# MEMO

<b>To:</b>	<b>NZ Clean Energy Ltd, Attn: Tracey Morse</b>	<b>Date:</b>	<b>07.03.25</b>
<b>From:</b>	<b>Joshua Raynes – Environmental Engineer</b>	<b>CC:</b>	
<b>Reviewed:</b>	Bronwyn Rhynd, Environmental Engineer	<b>CKL Ref:</b>	<b>A23288</b>
<b>Re:</b>	<b>1352 Homebush Road, Darfield- RC245775- RFI response Earthworks &amp; OLFP</b>

# AGRIVOLTAIC FACILITY

## 1352 HOMEBUSH ROAD, DARFIELD

PROPOSED TEMPORARY EARTHBOUND

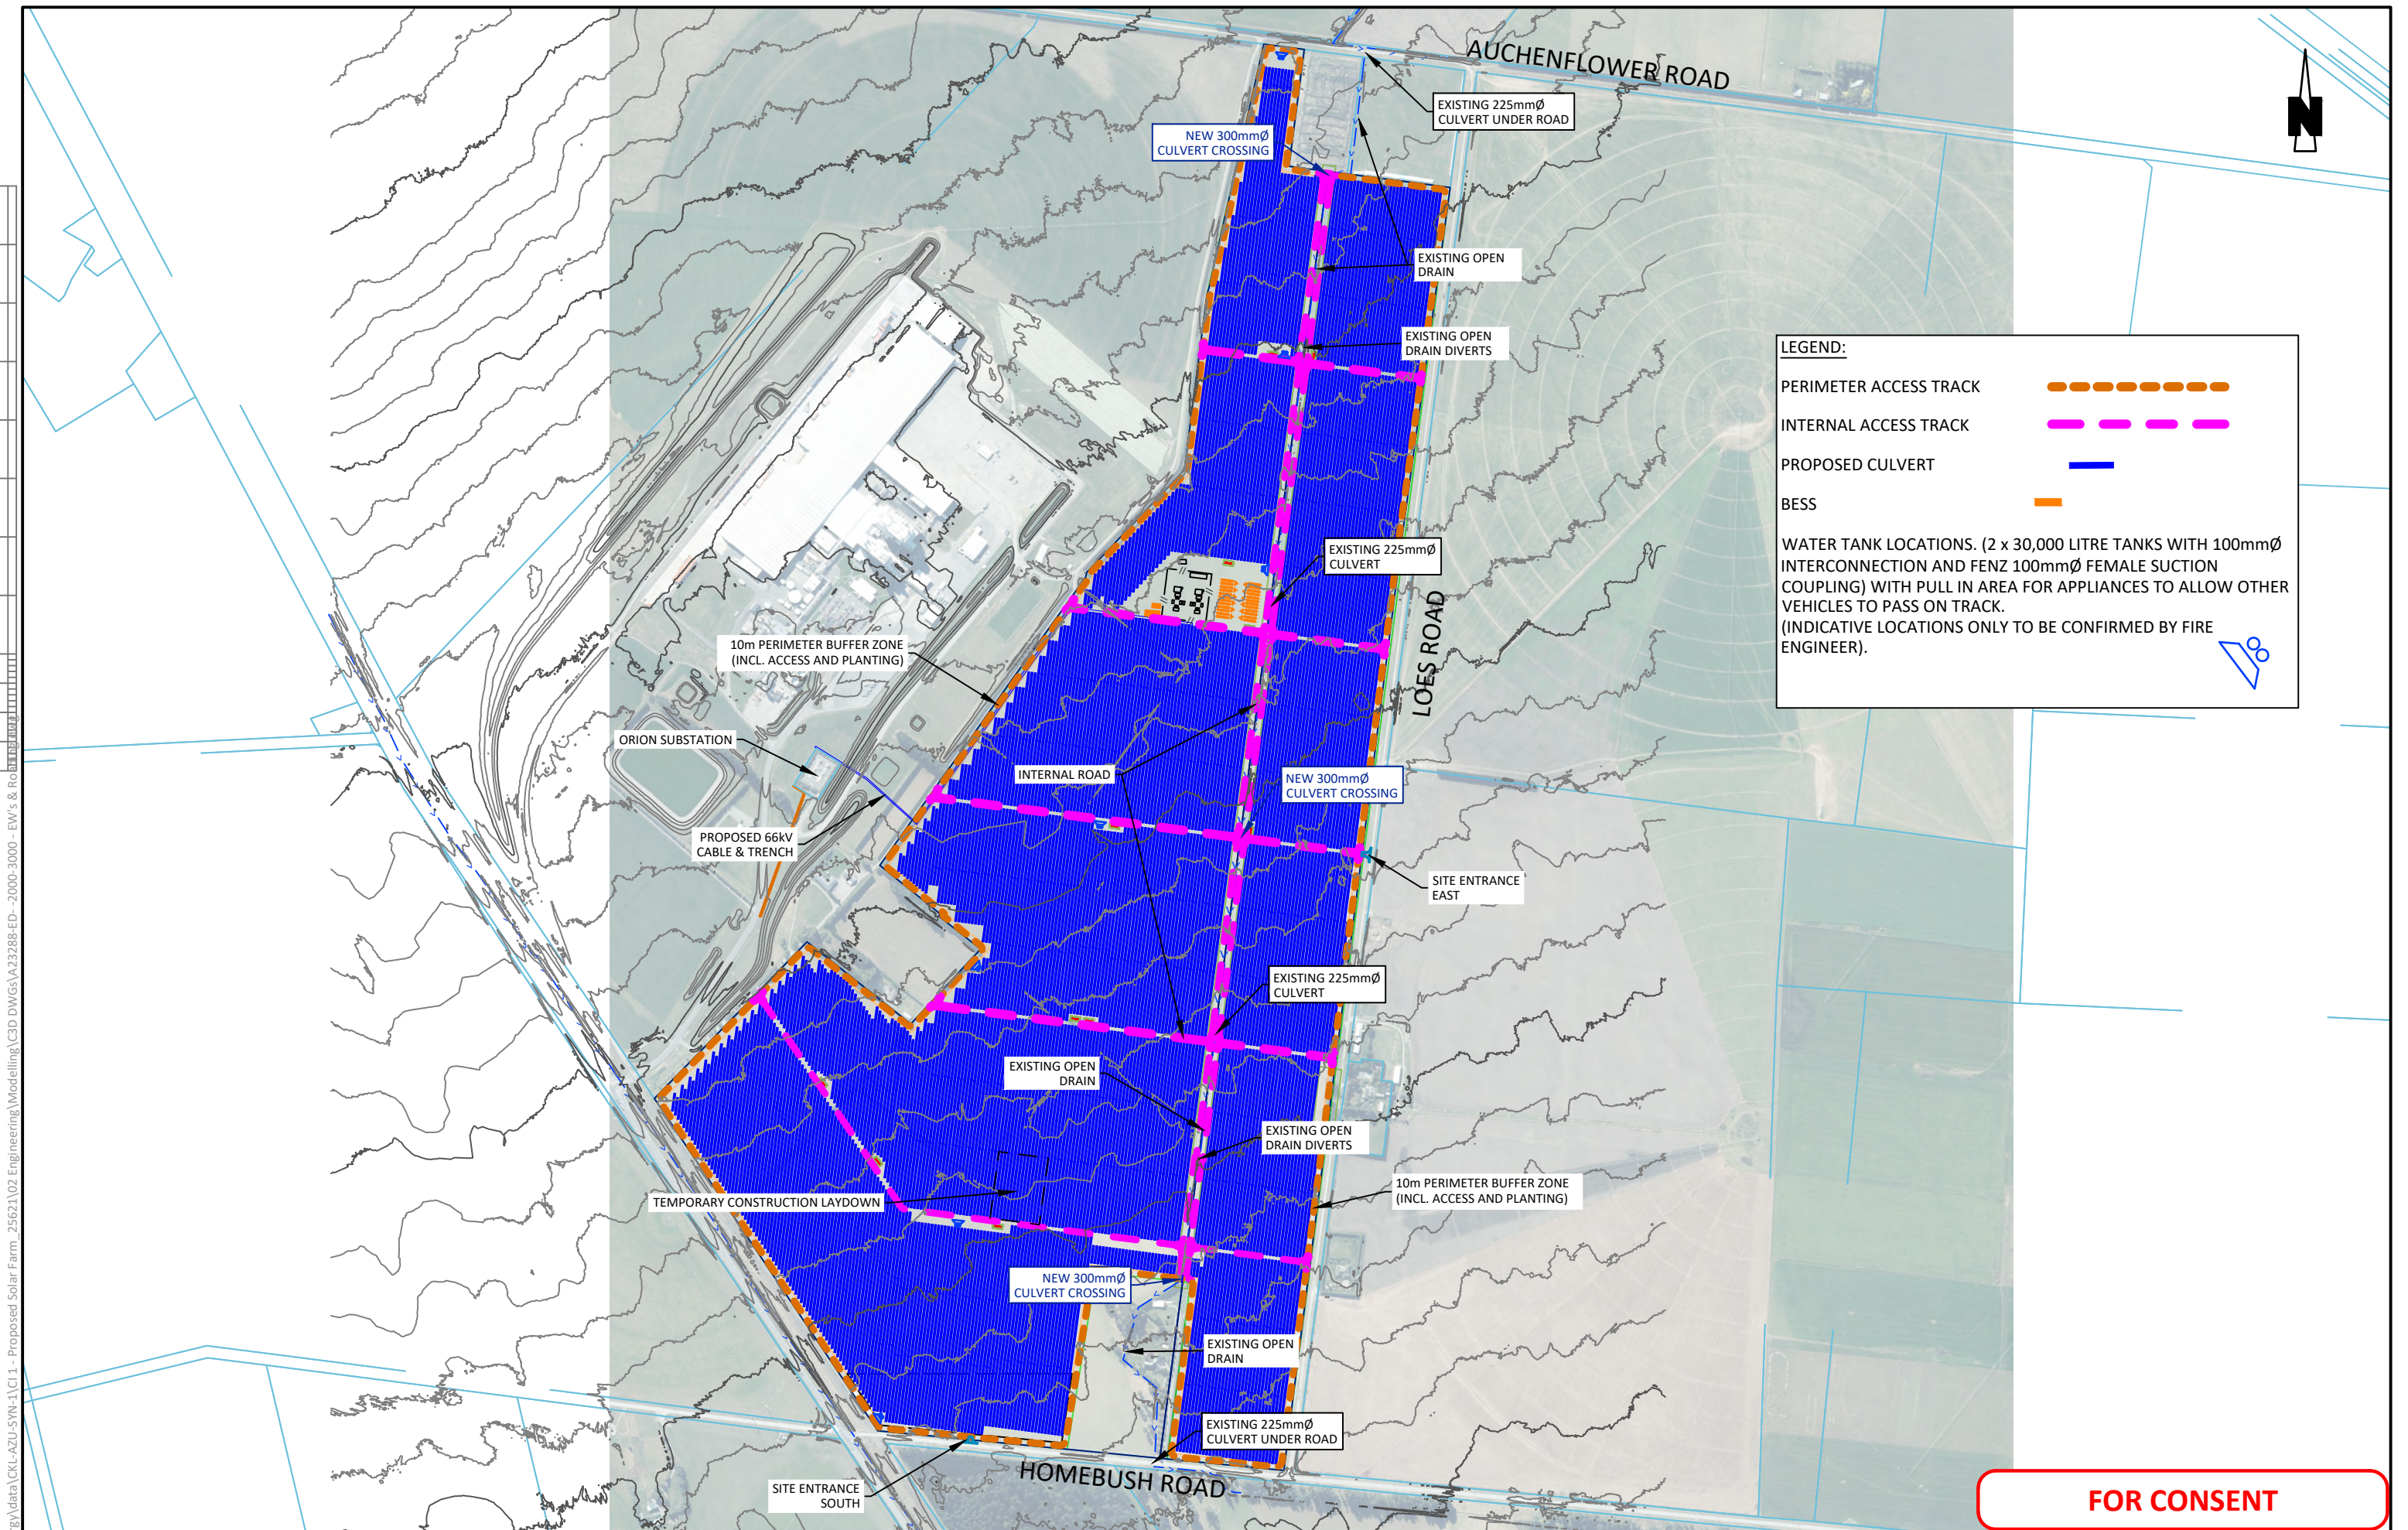
- 1. Please provide a net cut to fill plan to confirm that no changes to land drainage patterns will result from the proposed earthworks*
- 2. In the event that the result are not zero, please provide further information regarding how this will be addressed”*

The proposal for the earthworks includes areas of stripped topsoil for access tracks as shown in the CKL plans 2000-2002 & 3004. This stripped topsoil from the access track is to be spread over a width of 10-15m adjacent to the track to minimise the depth (of fill) and any potential impact on the OLFP that may be present in this area. This will result in approximately 100-150mm depth of topsoil being added to the existing natural ground level adjacent the access tracks. At this point in the design, i.e. prior to detailed design, a cut and fill plan is not deemed necessary due to the minor nature of the proposed earthworks and the minor fill depth.

STRIPPED TOPSOIL FROM THE ACCESS TRACK IS TO BE SPREAD OVER A WIDTH OF 10m - 15m ADJACENT TO THE TRACK TO REDUCE DEPTH AND ANY POTENTIAL IMPACT ON THE OLFP .
